ADVISORY
 BULLETIN

No. 2001-14

Spark Plug Fouling, 3.0 Litre Optimax

MERCURY/MARINER/TRACKER
2001 Model 3.0 Liter Optimax
S/N OT178500 Thru OT408999

57980

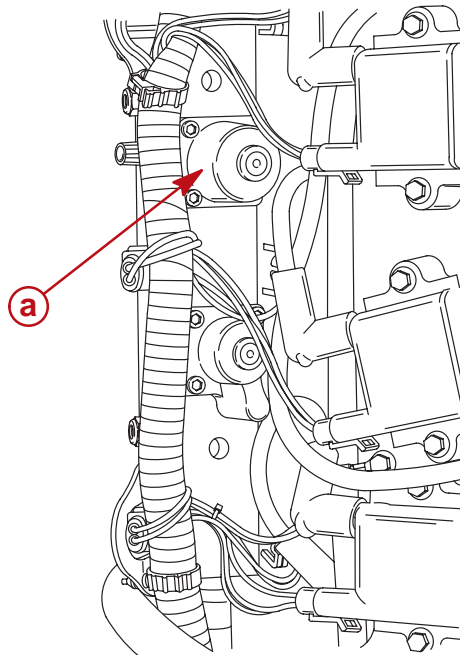
ENGINE OUT OF CARTON: Engines reworked at the factory, or dealer can be identified by the upgraded style air regulators on the port rail.

a - Upgraded larger cast aluminum regulator attached with 4 allen screws

FUEL RAIL and THERMOSTAT KIT: Kit will include:

- Port fuel rail, with new air regulator for improved dampening characteristics
- Replacement 120° thermostats
- Hardware and instruction sheet to install rail and thermostats
- Six (6) new spark plugs
